## Attachment 4: Wilton Growth Area Development Control Plan 2021 Assessment

Wilton Growth Area Development Control Plan Part 1 -8	X
North Wilton Precinct Schedule	X
North Wilton Precinct Schedule 2- Neighbourhood Plan No.1	X

Figure 3 Indicative Staging Plan

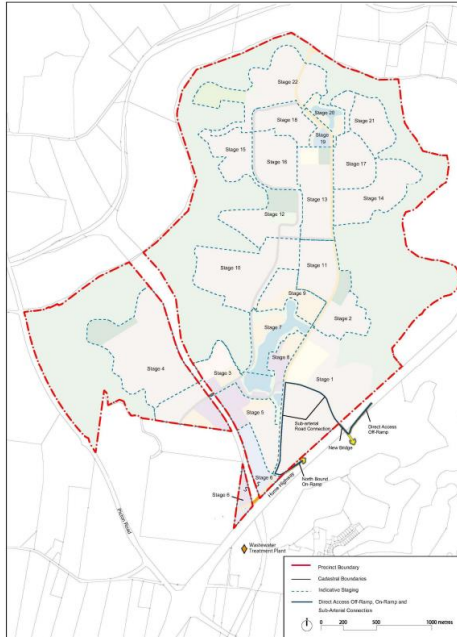
It is noted however that Figure 3 is indicative only, and no concerns with change to staging name arose during assessment of the application – noting area of the development is covered by a Neighbourhood Plan (Neighbourhood Plan No.1).

Figure 4: Indicative Water Cycle Management Strategy (to be refined at Neighbourhood Plan and Development Application Stage)

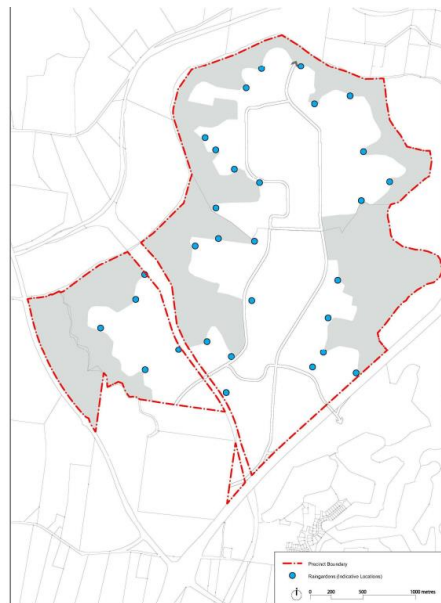
Refer to comments previously in the report, WCM infrastructure subject to conditions have been considered acceptable in the context and end of line treatment provided generally in accordance with Figure.

Figure 5: Aboriginal and Non-Aboriginal Cultural Heritage Sites (indicative Locations)

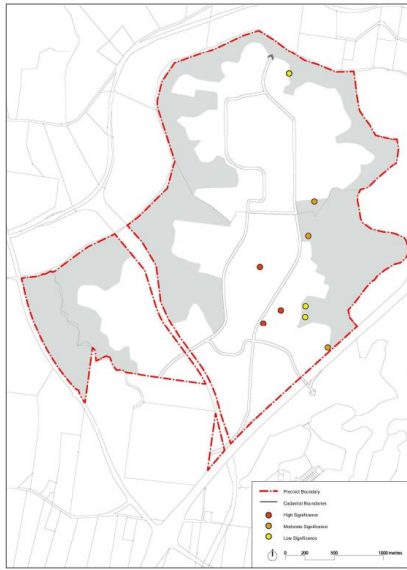
Noted, refer to earlier comments in the report, additional studies have been undertaken and bulk earthworks DA required to obtain AHIP prior to impacts to objects.

Figure 6: Indicative Bushfire Risk and Asset Protection Zone Requirements

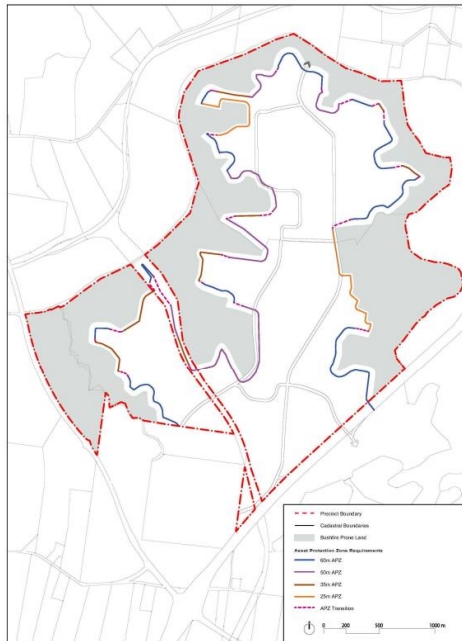
The proposal is considered consistent, recognising the areas identified in the figure as direction to threat.

A Temporary APZ on neighbour to the west (102) however is required until wider area developed. Refer to recommended conditions.

Figure 7: Indicative Public Transport Plan

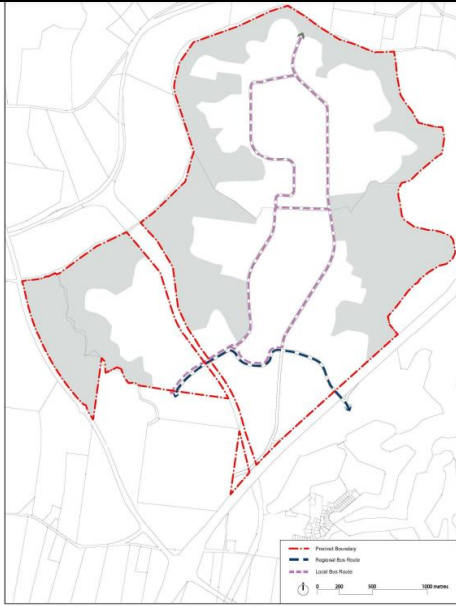
Noted, Sub Arterial Road construction considered appropriate for bus route.

Figure 8: Indicative Open Space and Recreation Network

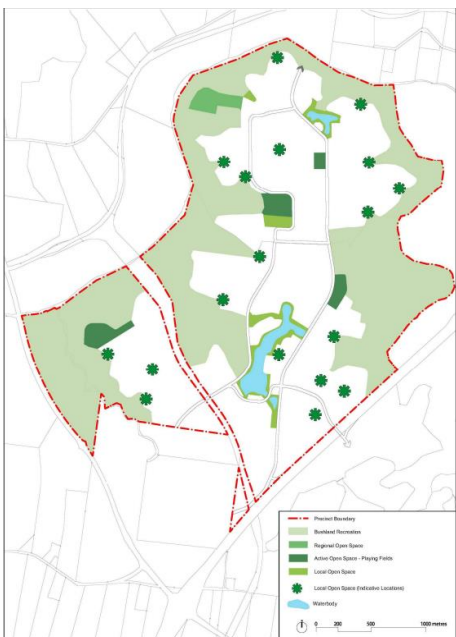
Noted Figure is indicative only.

Noted there have been amendments to the areas identified for open space in stage 2/3, refer to neighbourhood Plan No.1. The development however has been considered consistent with requirements as detailed in neighbourhood Plan No.1.

Figure 9: Indicative Precinct Road Hierarchy Plan

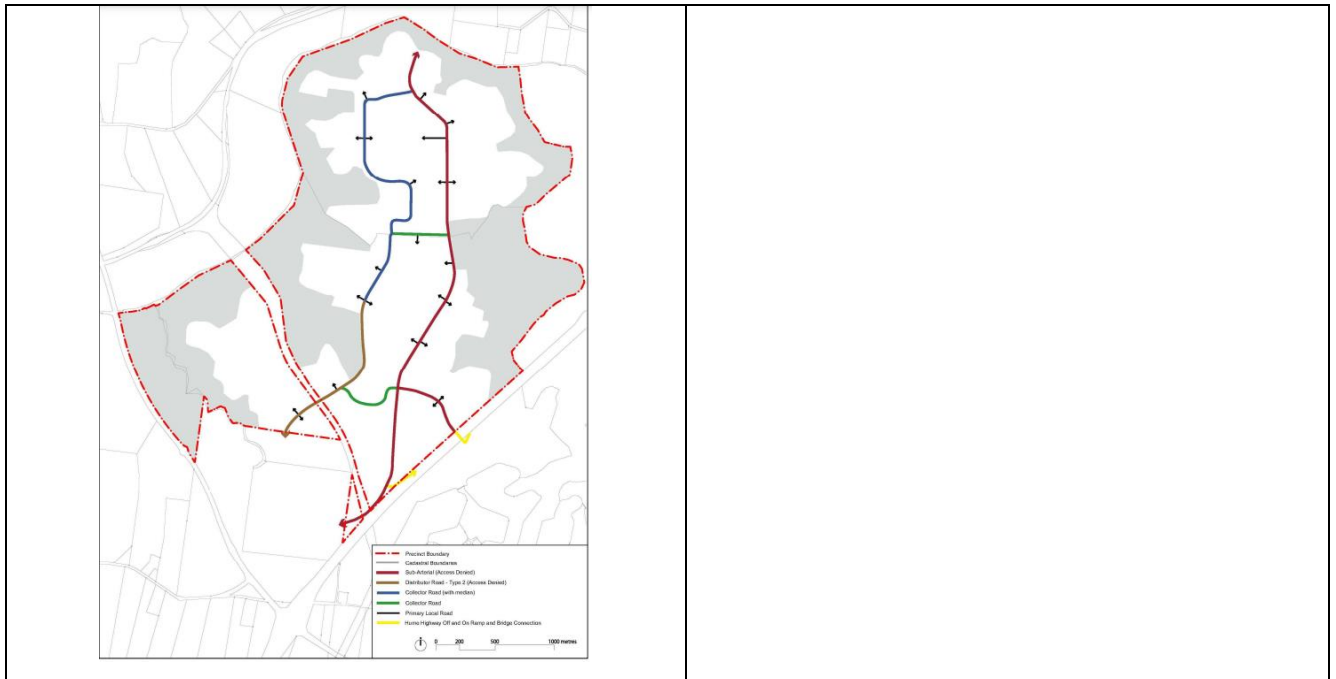
Identified Hume highway of ramp and sub arterial road around the development. Both considered during the assessment with subdivision design.

Figure 10: Indicative Pedestrian Cycle Network Plan

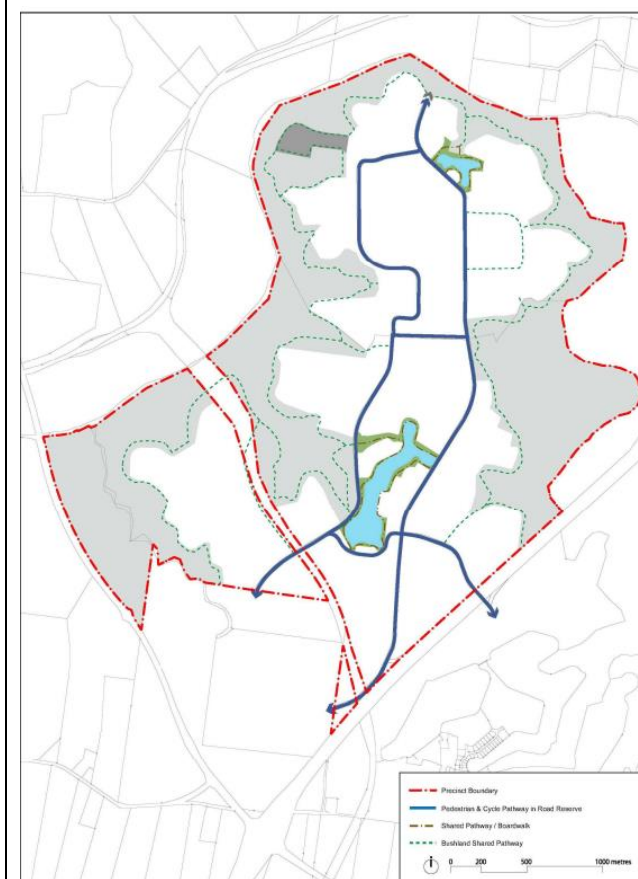
Noted Figure is indicative only. Share pedestrian and cycle paths have been provided along sub arterial road, considered consistent with Figure 10.

Figure 11: Indicative Noise Consideration Plan

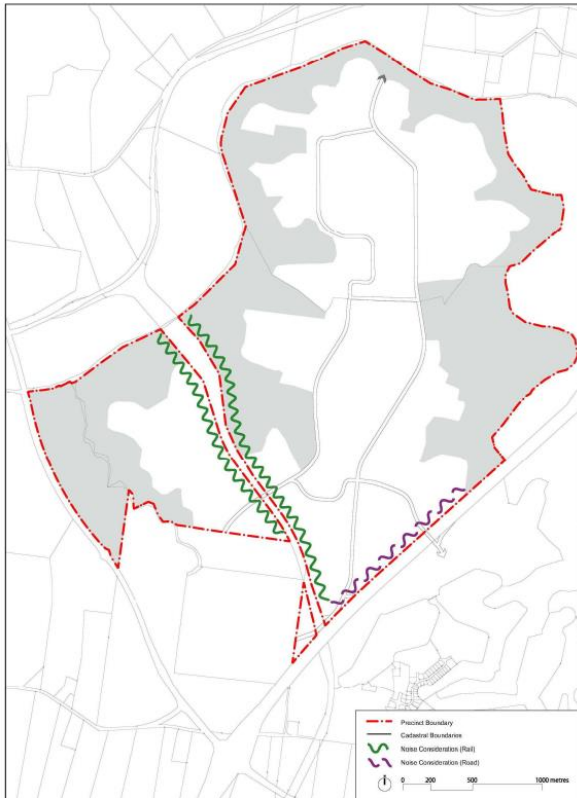
Noted Figure is indicative only.

An Acoustic Report was provided with the application which provided comment on identified

noise sources. Refer to comments in earlier sections of the report.

Figure 12: Indicative Special Urban Areas

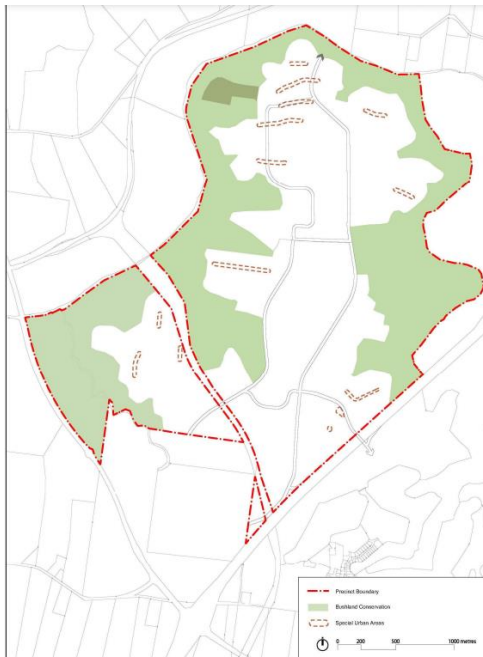
Proposal provides the special urban areas shown within stage 2 – refer to plans – area provided as green space and includes retained trees associated with bulk earthworks DA.
